SUBJECT: ST. LUCIE PLANT, UNIT NO. 2 - ISSUANCE OF AMENDMENT NO. 206 TO
REPLACE THE CURRENT TIME-LIMITED REACTOR COOLANT SYSTEM
PRESSURE/TEMPERATURE LIMIT CURVES AND LTOP SETPOINTS WITH
CURVES AND SETPOINTS THAT WILL REMAIN EFFECTIVE FOR
55 EFFECTIVE FULL POWER YEARS (EPID L-2020-LLA-0029)

SAFETY EVALUATION BY THE OFFICE OF NUCLEAR REACTOR REGULATION

RELATED TO AMENDMENT NO. 206

ST. LUCIE PLANT, UNIT NO. 2

FIGURE 3.4-2

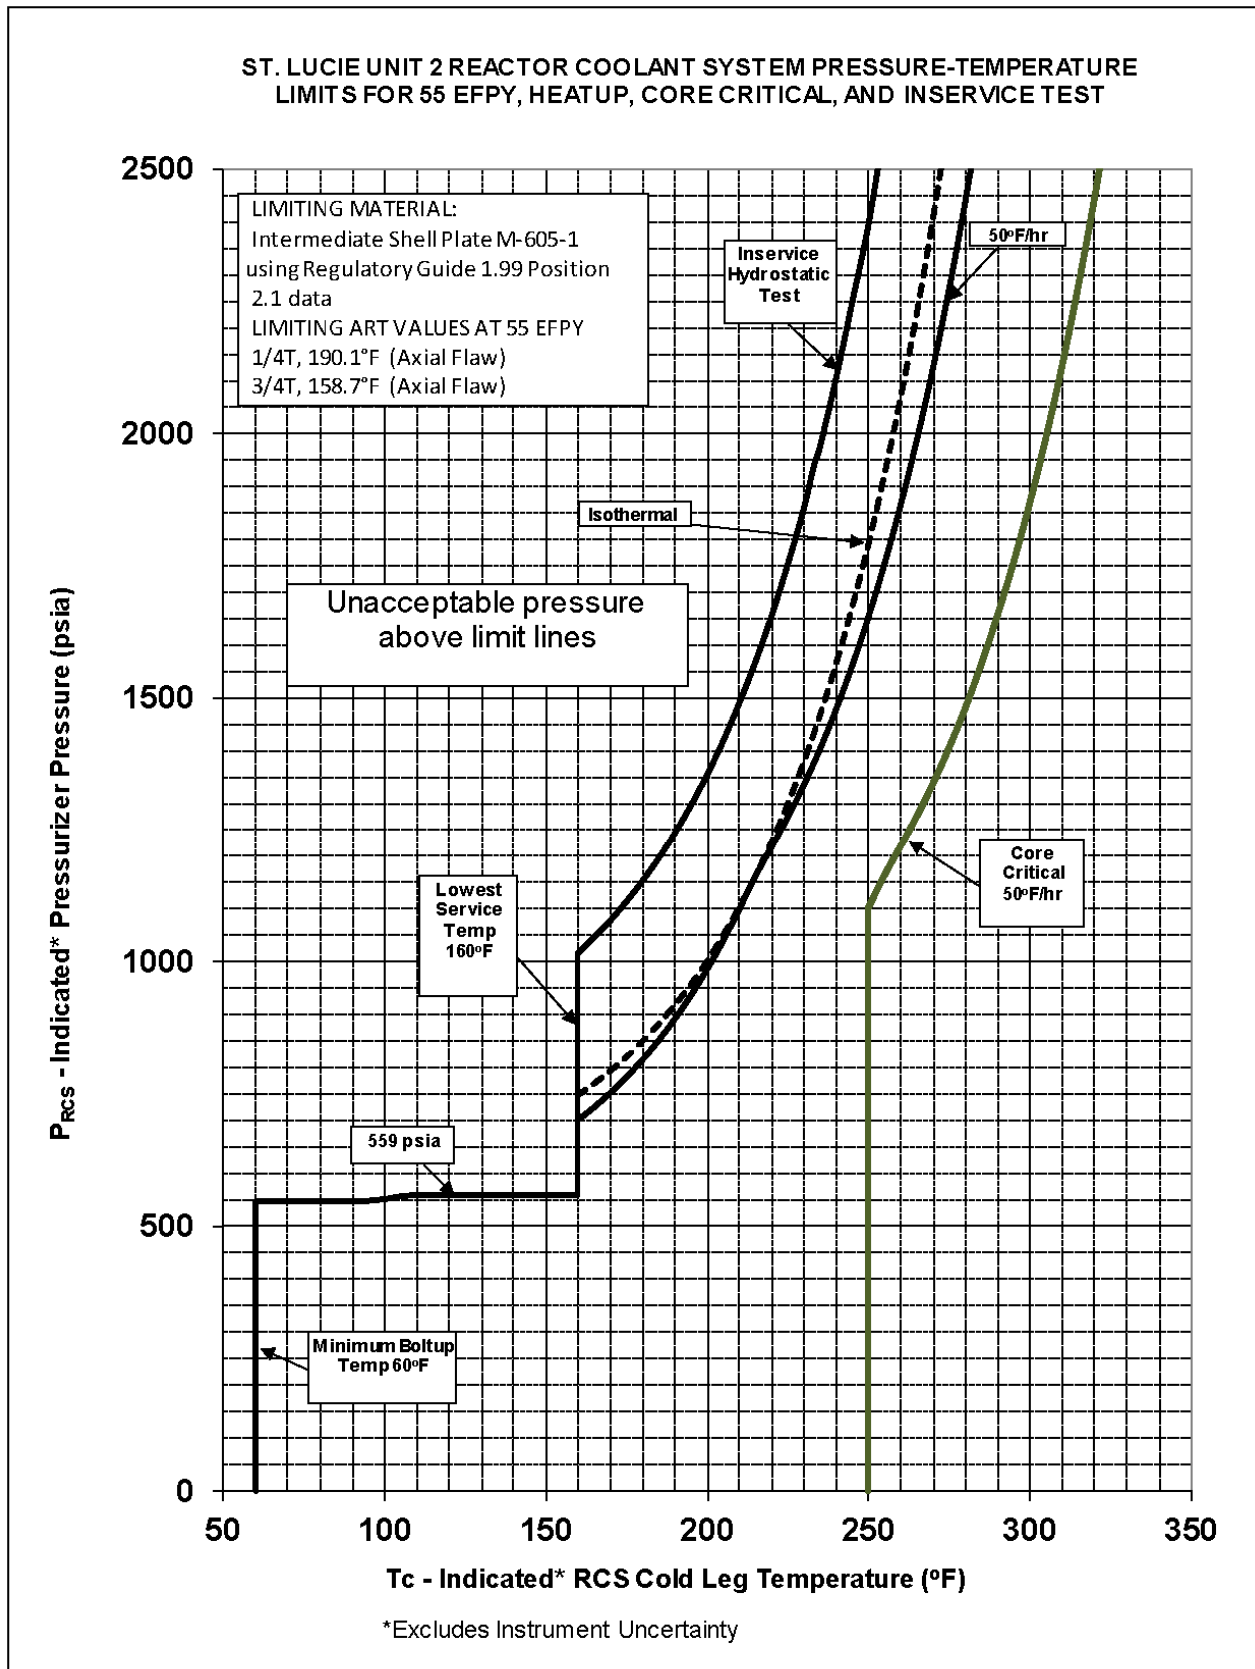
The NRC staff evaluated the licensee's proposed 55 EFPY RCS P/T limits for heatup, core critical, and inservice test shown in replacement Figure 3.4-2 in Attachment 4 of the LAR application and the proposed 55 EFPY RCS P/T limits for cooldown and inservice test in replacement Figure 3.4-3 in the same attachment. Using the limiting ART values, the staff independently calculated P/T limits based on the related equation in Appendix G to Section XI of the ASME Code. However, this was done with the thermal stress intensity factor computed from a one-dimensional thermal stress analysis across a vessel wall. The staff compared its calculated values with those in the 55 EFPY P/T limits data in Tables 7-1 through 7-3 of WCAP-18275-NP and determined that the licensee's proposed 55 EFPY P/T limits are consistent with the methodologies in Appendix G to Section XI of the ASME Code and WCAP-14040-A, Revision 4. The staff verified that the cooldown P/T limits in Figure 3.4-3 are those corresponding to the cooldown rates shown in the figure: a rate of 100°F per hour down to a temperature of 212°F and a rate of 50°F per hour down to a temperature of 60°F. In addition, based on the flange and balance of reactor coolant system RT_{NDT} values in Table 3-2 of WCAP-18275-NP, the staff verified that flange requirements of 10 CFR Part 50, Appendix G, Paragraph IV.A.2 are bounded by the lowest service temperature (LST) requirements of NB-3211 and NB-2332 of Section III of the ASME Code.

The staff noted that the y-axis of the proposed 55 EFPY RCS P/T limits in Figures 3.4-2 and 3.4-3 in Attachment 4 of the LAR application is the indicated pressure at the pressurizer. Since there is a pressure head difference between the pressure at the pressurizer and the pressure at the RPV beltline, the staff verified that the licensee applied the actual pressure correction factor (APCF) of 77.1 psi to the proposed 55 EFPY RCS P/T limits to account for the static and dynamic head difference between the pressurizer instrument location and RPV beltline. The licensee applied the APCF by subtracting 77.1 psi from the calculated allowable pressure values in Tables 7-1 through 7-3 of WCAP-18275-NP.

The licensee stated that the proposed 55 EFPY RCS P/T limits shown in replacement Figures 3.4-2 and 3.4-3 in Attachment 4 of the LAR application do not include instrument uncertainty. In Section 4.0 of Attachment 1 of the LAR application, the licensee stated that LTOP system enable temperatures and pressure setpoints included instrument uncertainties in the transient analysis performed to determine those setpoints. The NRC staff finds this acceptable since it means that instrument uncertainties would be accounted for when the LTOP system is enabled (i.e., when RCS temperatures are less than or equal to the LTOP enable temperatures). At RCS temperatures greater than the LTOP enable temperatures, the licensee stated that RCS operation below and to the right of the proposed 55 EFPY P/T limits are

As shown in the proposed TS Figure 3.4-2, during heatup, the peak transient pressure of 546.5 psia between 60°F and 200°F does not exceed the P/T limits within that temperature range. In addition, the peak transient pressure of 677 psia between the LTOP enable temperatures of 200°F and 252°F does not exceed the P/T limits within that temperature range. The staff, therefore, finds this acceptable.

administratively controlled with margins greater than the instrument uncertainty. Accordingly, the staff finds the licensee's treatment of instrument uncertainty acceptable. Based on the evaluation above, the staff finds the licensee's proposed 55 EFPY RCS P/T limits for heatup, cooldown, core critical, and inservice test of St. Lucie, Unit 2 acceptable.

FIGURE 3.4-3

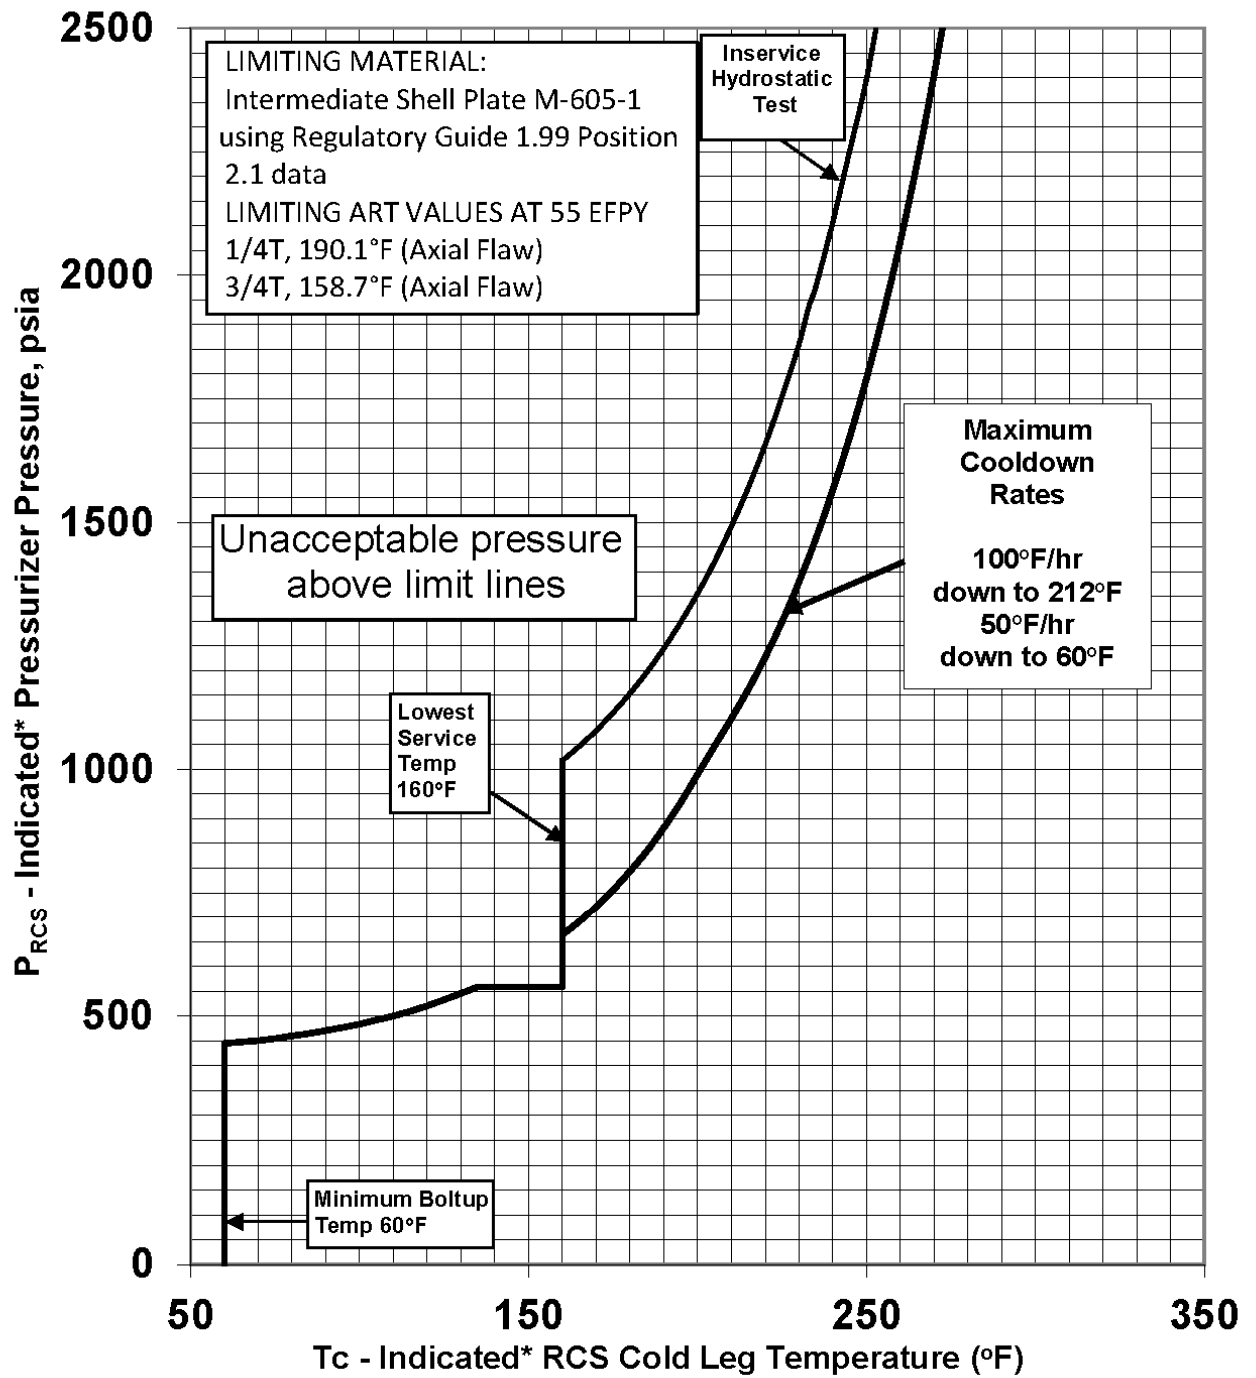
The proposed TS Figure 3.4-3 shows that during cooldown, the peak transient pressure of 546.5 psia between 149°F and 200°F does not exceed the allowable cooldown limits within that temperature range. In addition, the peak transient pressure of 677 psia between the LTOP enable temperature range of 200°F and 240°F does not exceed the P/T limits within that temperature range. Therefore, the staff finds this acceptable.
